UNITED STATES PATENT AND TRADEMARK OFFICE

| APPLICATION NO. | FILING DATE | FIRST NAMED INVENTOR | ATTORNEY DOCKET NO. | CONFIRMATION NO. |
|-----------------|-------------|----------------------|---------------------|------------------|
| 10/050,830 | 01/18/2002 | Gen Sasaki | 111695 | 6926 |

Office Action Summary

DETAILED ACTION

Fig. 8 Prior Art

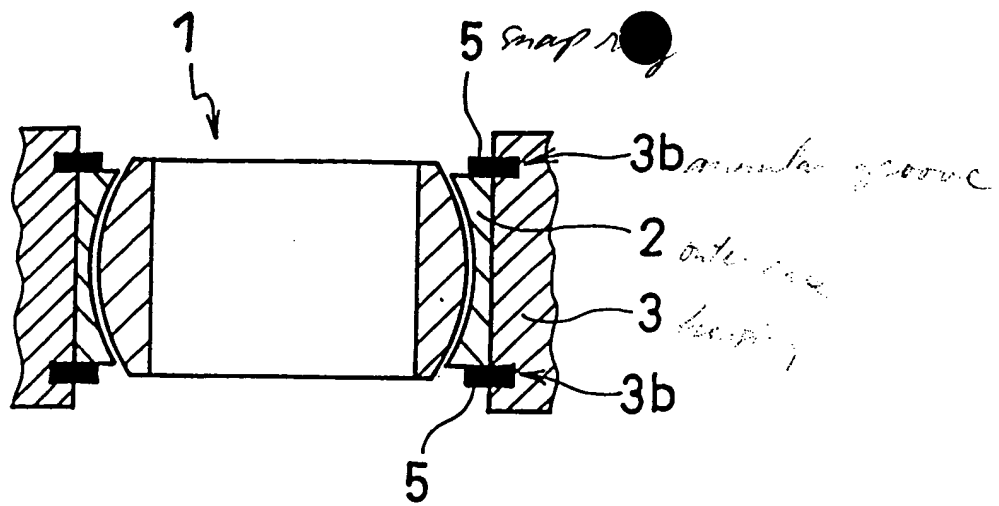
2. Claim 1 is rejected under 35 U.S.C. 102(a) as being anticipated by Applicant's Admitted Prior Art (as set forth on pages 1-2, lines 1-5 of page 3 of the specification, and Figures 6-12, hereinafter is referred to as AAPA).

AAPA discloses a method of retaining a bearing in a hole formed in a housing comprising: inserting the bearing (1) in the hole; plastic flow to an inner peripheral surface of the hole toward an end face of an outer race of the bearing using a staking tool (6) with a diameter larger than that of the hole, and smaller than that of an outer diameter of the housing; forming a locking section (3c) for retaining the end face of the outer race (2) by the plastic flow for retaining the outer race of the bearing in the housing (see especially Figure 8 as attached at the end of this Office Action for further detail explanation).

8. In response to applicant's argument that AAPA does not disclose providing plastic flow to an inner peripheral surface of the hole toward an end face of an outer race of the bearing and forming a locking section on the end face of the outer face by the plastic flow for retaining the outer race of the bearing in the housing, as recited in claim 1, the applicant is referred to paragraph #2 above for further explanation.

specification, limitations from the specification are not read into the claims. See *In re Van Geuns*, 988 F.2d 1181, 26 USPQ2d 1057 (Fed. Cir. 1993). Furthermore, a fair reading of the claim language permits the examiner to interpret that the staking tool 6 in Figure 8 Prior Art is applicable to be use to provide a plastic flow to an inner peripheral surface of the hole toward an end face of an outer race of the bearing for retaining the outer race of the bearing in the housing.
